Technical News Bulletin

Cham, May 2015

Type II Shear Tension Arm and Drop Guide 565-205

Triple Gob 3" Center Distance, Ref. 565-205-1

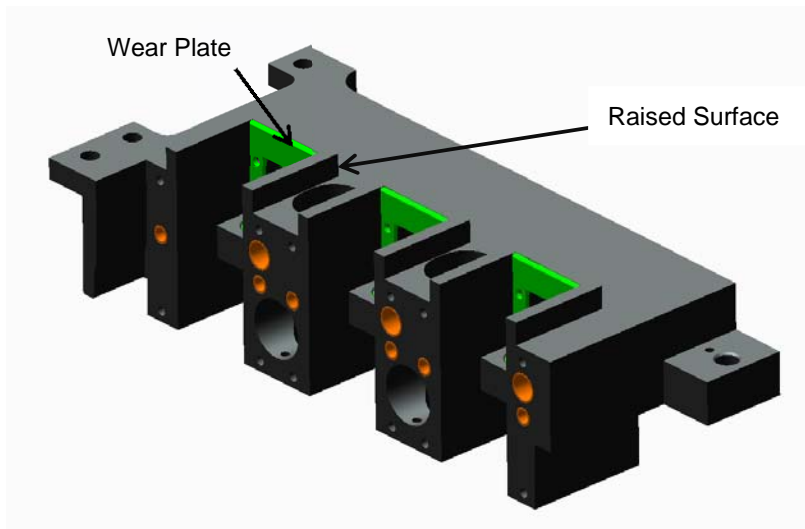
The Tension Arm and Drop Guide assembly contains most of the moving components on the shear mechanism. With the ever increasing cut rates required for additional sections and increased production speed the service life of the components is causing problems for many of our customers. The improved version of the unit shows little change in the external appearance to ensure full compatibility with the original assemblies. Many of the components have been revised in the form of material and dimensional change to give greater stability of the drop guides and a more rigid platform for the shear blades. These changes improve service life ensuring reduced shear blade wear and shearing defects.

The Tension Arm unit has the area around the blade holder raised to give an additional bearing surface for the shear blade holder. This surface is further protected with a 2mm hardened stainless steel wear plate. All bushings for the drop guide slider and the adjusting shafts are all nitride hardened steel.

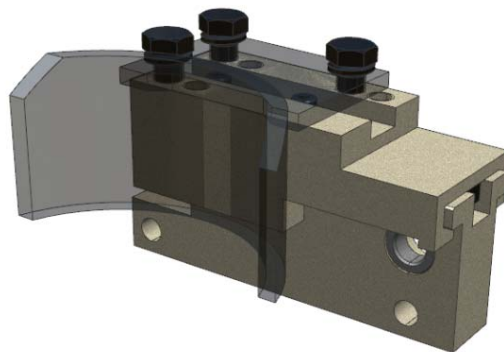
The Drop Guide assemblies 565-206-1 /2 /3 are a complete rework of the previous units and all components have been changed. The interfaces however remain the same at the tension arm and the original drop guides can also be used. The changes are to ensure that unwanted movement (wobble) of the drop guides is kept to minimum during operation of the shear mechanism.
